**APPLICATION FOR PERMISSION  
UNDER SECTION 16 OF  
THE TOWN PLANNING ORDINANCE  
(CAP. 131)**

For Official Use Only 請勿填寫此欄	Application No. 申請編號	A/TL-TYST/1339
	Date Received 收到日期	14 OCT 2025

**Proposed Temporary Warehouse (Non Dangerous Goods) for a Period of 3 Years**  
**at**  
**Lots 835 S.A, 835 S.B (Part), 836 (Part) & 837 (Part) in D.D. 119, Pak Sha Tsuen, Yuen Long, N.T.**

Proposed Drainage Plan

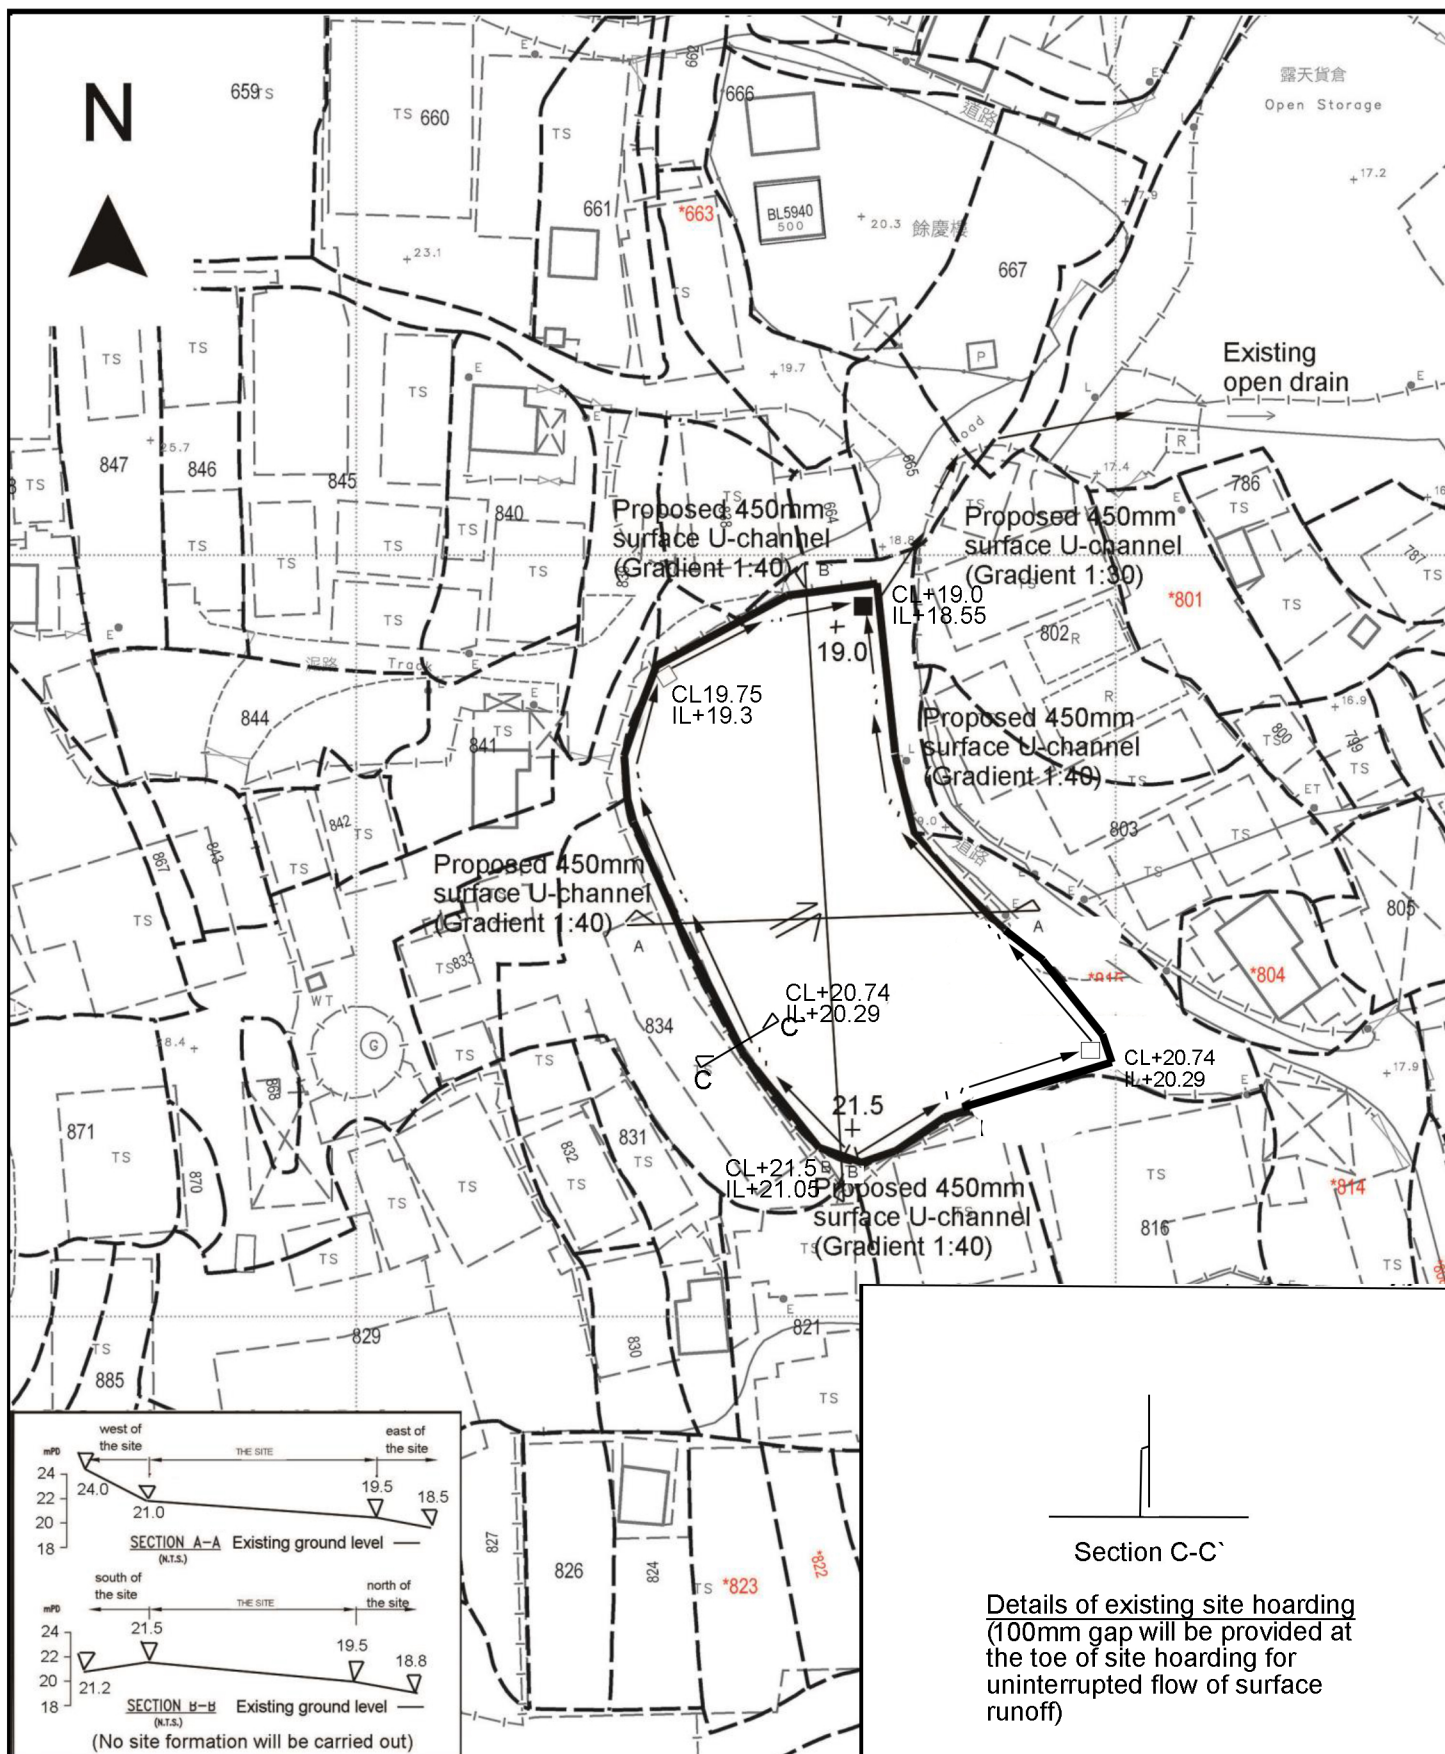
- no in-principle objection to the application from a drainage point of view and no adverse comment on the submitted drainage proposal provided that all existing drains/watercourse should be maintained and the overland flow from adjacent lands should not be affected;

- should the application be approved by the Town Planning Board (the Board), approval conditions requiring the implementation and maintenance of the accepted drainage proposal to the satisfaction of the Director of Drainage Services or of the Board should be stipulated.

1.3.1 Subject to the calculations in 1.2 above, it is determined that proposed 450mm concrete surface U-channel at gradient of about 1:40 along the site periphery is adequate to intercept storm water passing through and generated at the application site (**Figure 4**).

- 1.3.2 The collected stormwater will then be discharged to the existing open drain to the northeast of the application site. Sand trap or alike will be provided at the terminal catchpit before the stormwater is discharged to the public drainage.

Proposed Fire Service Installations Plan

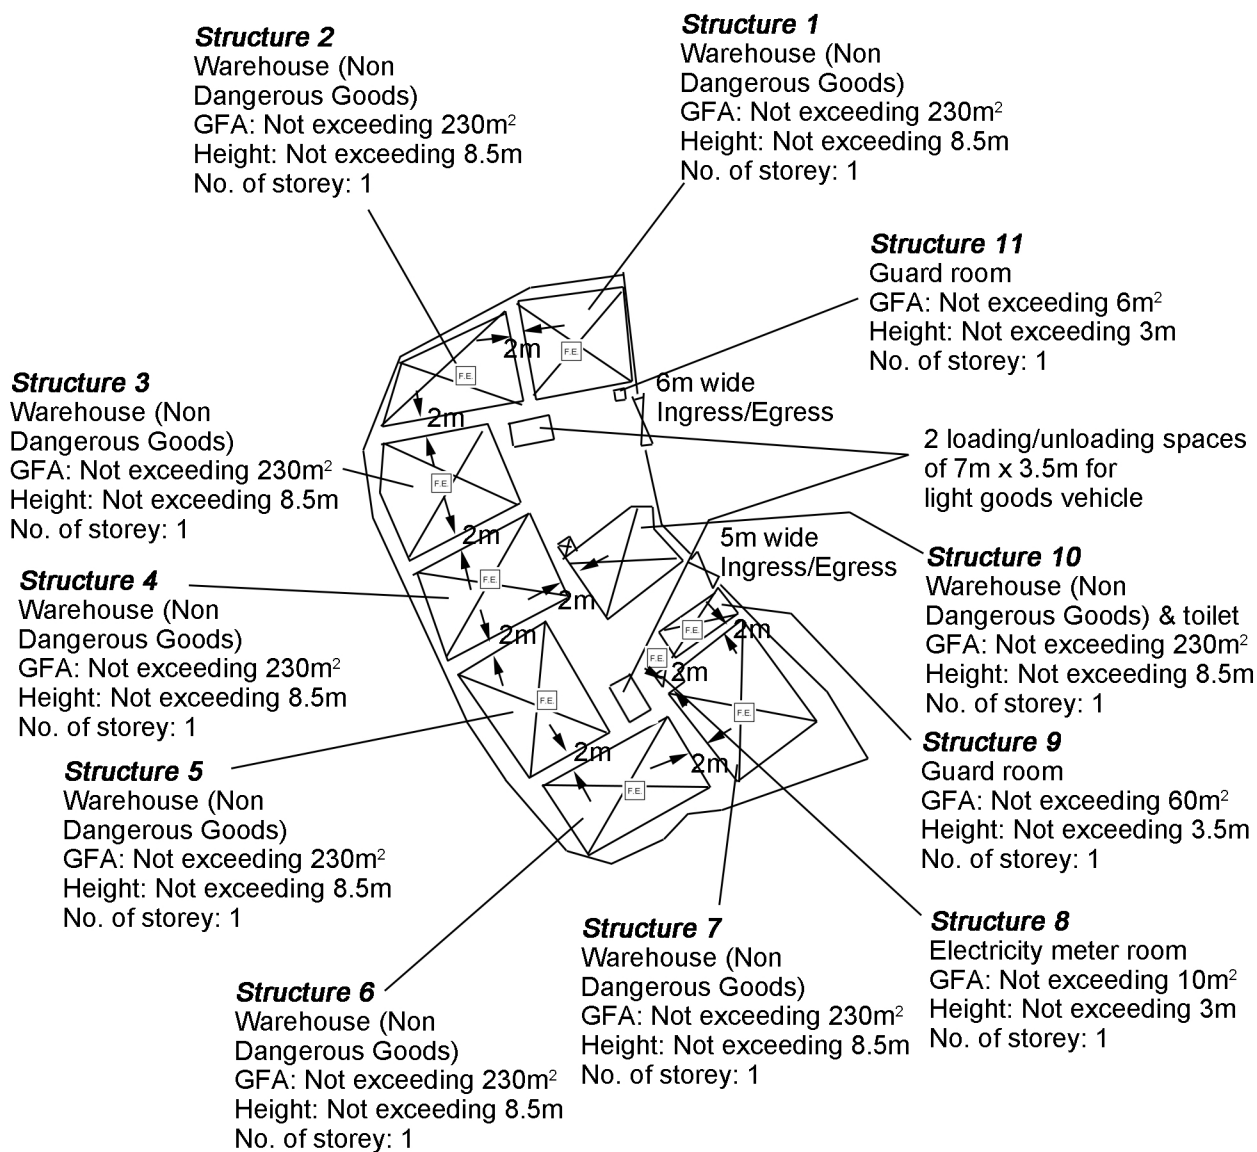
- (iv) if the proposed structures are required to comply with the Buildings Ordinance (BO) (Cap. 123), detailed fire services requirements will be formulated upon receipt of formal submission of general building plans;

We are also glad to submit the FSI plan (Figure 9) herewith for the consideration of the Director of Fire Services (D of FS).
